# TECHNICAL BULLETIN

## Intermittent High Idle – Replace Throttle Return Springs

19-33

MODEL XJ12 (6.0L) 1994 MY

ILLUSTRATION 1

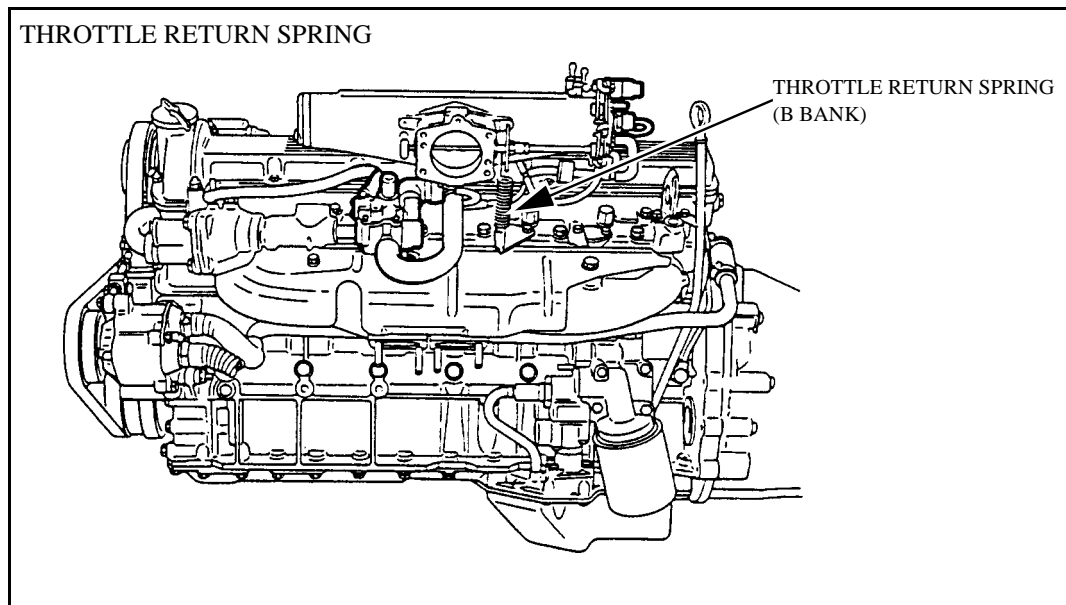
Some 1994 MY XJ12 Sedan Range vehicles may experience an intermittent high idle speed of approximately 900 rpm (normal idle speed, 750 rpm in neutral). This condition occurs when slowly returning the throttle to the idle position.

Revised throttle springs with increased preload were installed on all 6.0L engines beginning with 1995 MY production.

If customers of 1994 MY XJ12 vehicles complain of intermittent high idle speed, replace the existing throttle return springs with two revised springs (part number NAC 3030AB) as follows:

1. Remove throttle return spring from the throttle body, Illustration 1.
2. Install the new spring first to the bracket, then to the throttle lever.
3. Repeat the procedure on the throttle body on the opposite bank.
4. Check for correct throttle return operation.
